Public Input No. 3834-NFPA 70-2023 [Definition: Array.]

A mechanically and electrically integrated grouping of modules with ~~support structure~~ mounting system, including any attached system components such as inverter(s) or dc-to-dc converter(s) and attached associated wiring. (690) (CMP-4)

Informational Note Figure 690.1

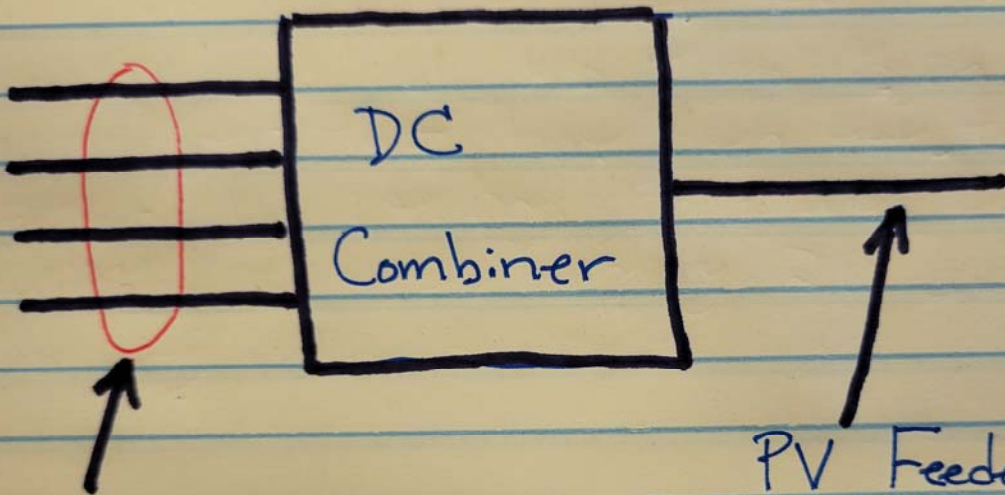
The lower current INPUT and the combined higher ampacity OUTPUT conductors from the combiner box should be distinctly annotated to clarify the direction of power flow in the system

Resolution: The terms “string” and “source” are defined terms that are already used to describe the input circuits to a combiner box. String circuits are a subset of source circuits. “Branch circuit” is a defined term not applicable to PV systems. Power flow direction is indicated by Figure Informational Note 690.1. The definition for “source circuit” is not dependent on the level of current flow on the circuit conductors. Increased clarity is not achieved through a new term for the output circuit of a combiner box.

Figure Informational Note Figure 690.12(D) Label for Roof-Mounted PV Systems with Rapid Shutdown.

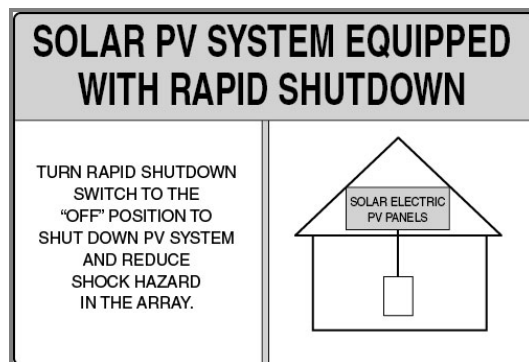
The word "is" is not in Figure 690.12(D).
